Revision A
 20 A and no 18 to share a new party wall - hatched red.

RyanMarshall Architects		
for Asher, Louise and Chloe, 20 Brookfield Park NW5		
Proposed plan and elevations	013/03	Rev A
1:100@ A3 1:50@A1	June 2020	
g.ryan@ryanmarshall.co	07973 72 00 88

proposed side elevation

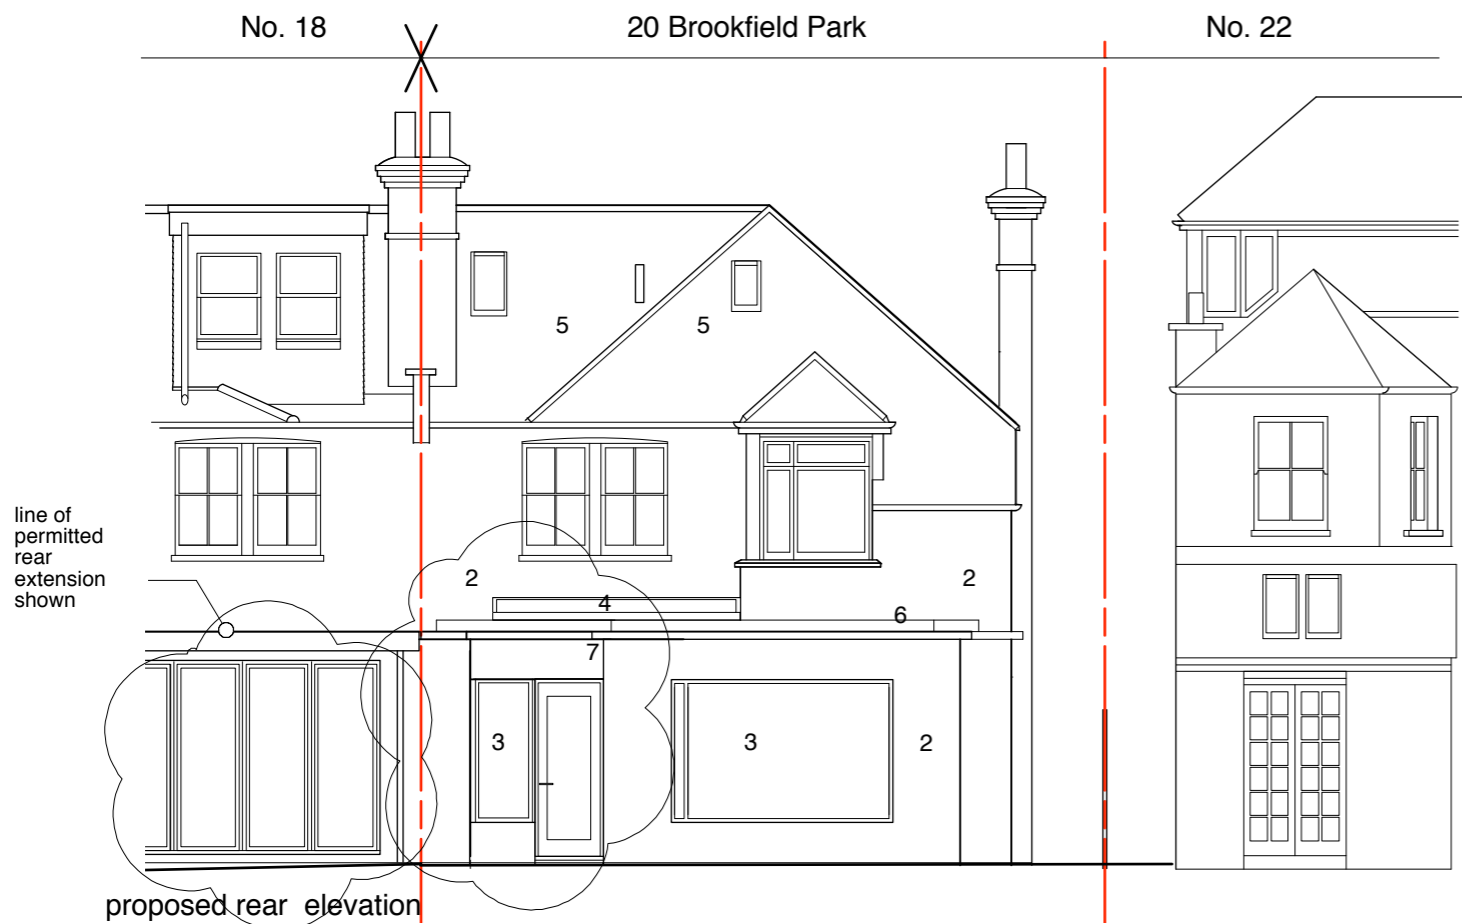
flat roofs to line through at perimeter height of 3m above ffl

Rooflight to no 20A revised to lower pitch flat glass roof to reduce roof profile

proposed plan (ground floor)

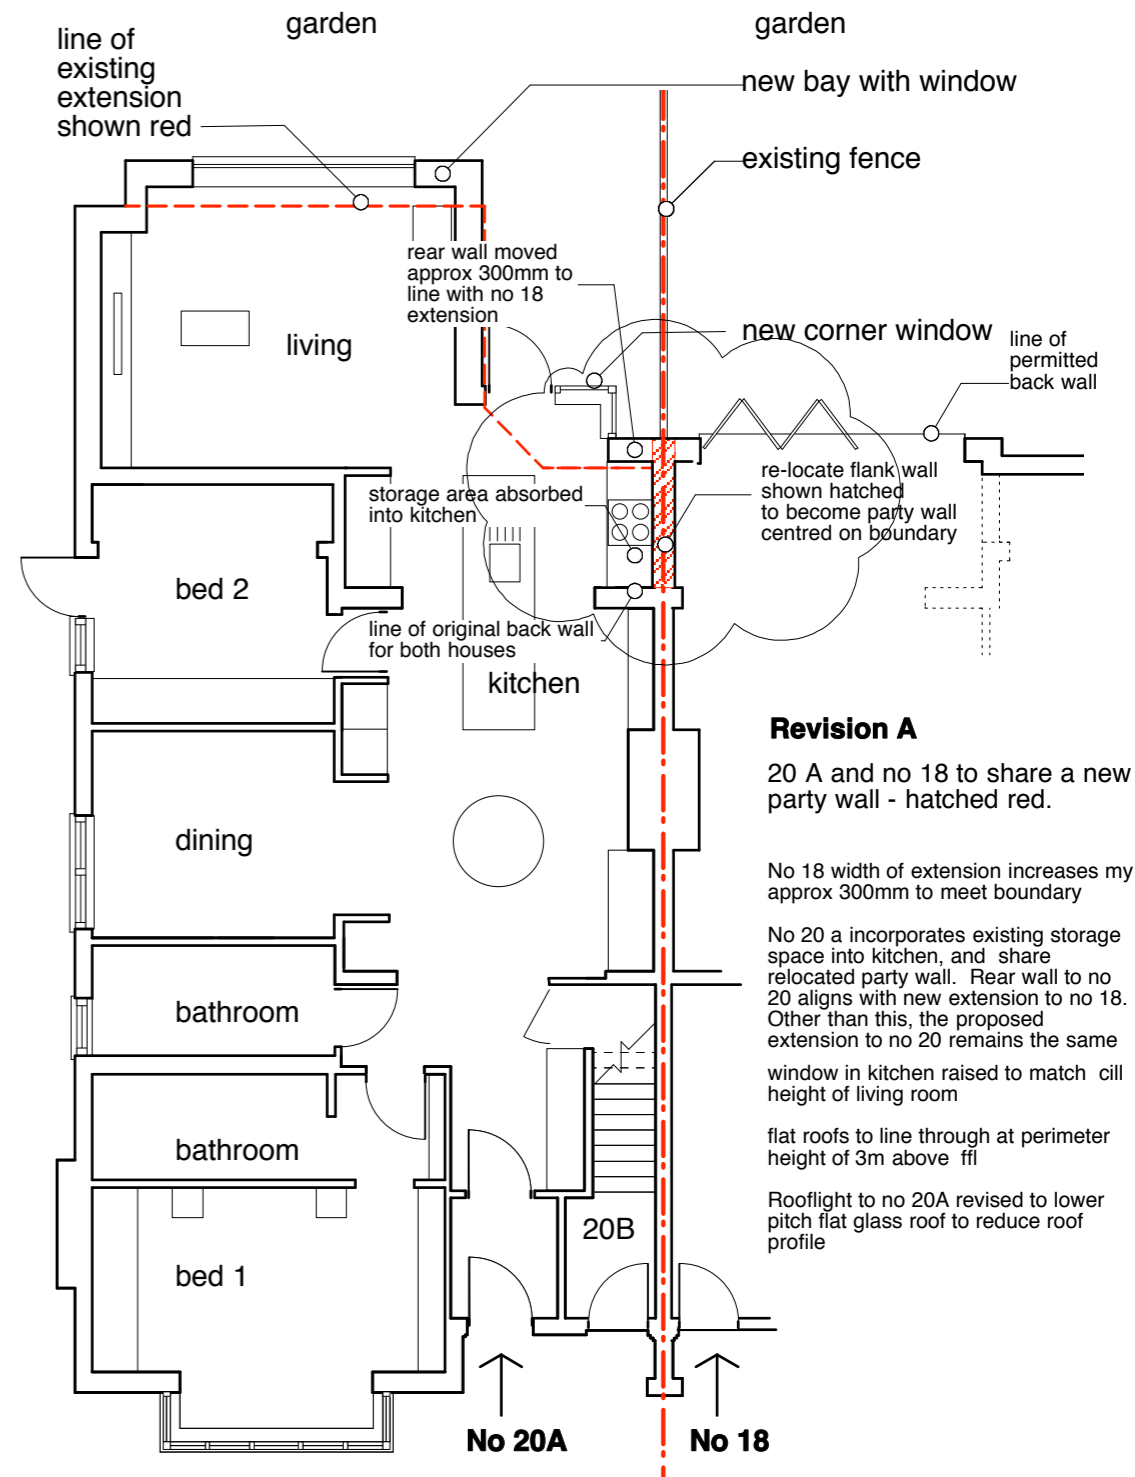
No 18 width of extension increases by approx 300mm to meet boundary

No 20 a incorporates existing storage space into kitchen, and share relocated party wall. Rear wall to no 20 aligns with new extension to no 18. Other than this, the proposed extension to no 20 remains the same
